Access Compliance Report

Public Rights-of-Way

Intersection ID: 27059	Main Street: CURRIE RIDGE DR	Cross Street: SIR FRANCIS DRAKE DR	Location: SE
ADA ID: F4AA2E51C42A	Ramp Type: PerpDiag	Initial Pass/Fail: Fail	Overall Compliance: No
Severity Score: 48.75			
Codes/Mitigation Info/Possible Solution		Field Measurements/Component Compliance

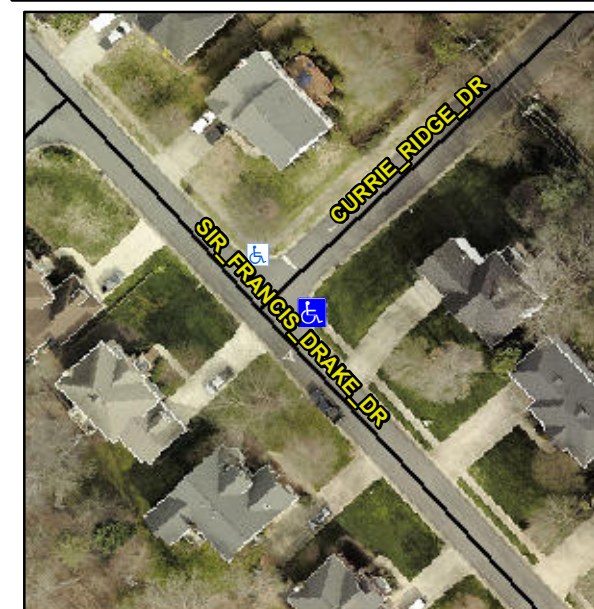
Not Found, R304.5.1, R304.2.2, R304.5.3

Compliance	Description	Data	Compliance	Description	Data
N/A	Ramp Length (in)	98.0	No	Ramp Slope (%)	9.5
No	Ramp Width (in)	28.0	No	Ramp XSlope (%)	2.7
N/A	Flare Type LT	N/A	N/A	Flare Type RT	N/A
N/A	Flare Slope LT (%)	N/A	N/A	Flare Slope RT (%)	N/A
N/A	Flare Traversable LT?	N/A	N/A	Flare Traversable RT?	N/A
N/A	Landing Length (in)	N/A	N/A	DWS Provided?	N/A
N/A	Landing Width (in)	N/A	N/A	DWS Contrast?	N/A
N/A	Landing Slope (%)	N/A	N/A	DWS Length (in)	N/A
N/A	Landing X Slope (%)	N/A	N/A	DWS Full Width?	N/A
N/A	Landing Curb? (Y/N)	N/A	N/A	DWS Offset (in)	N/A
N/A	Shared Landing?	N/A			
N/A	Gutter Ponding?	N/A	N/A	Gutter Slope (%)	N/A
N/A	Gutter Lip Ht (in)	N/A	N/A	Gutter X Slope (%)	N/A
N/A	Painted X Walk1?	No	N/A	Painted X Walk2?	No
	X Walk 1 Direction	To NW		X Walk 2 Direction	To SW
N/A	X Walk 1 Width (in)	N/A	N/A	X Walk 2 Width (in)	N/A
	X Walk 1 Slope (%)	4.8		X Walk 2 Slope (%)	2.4
	X Walk 1 X Slope (%)	1.5		X Walk 2 X Slope (%)	5.0

Remove & Replace Curb Ramp With Two New Directional Ramps or Equivalent.
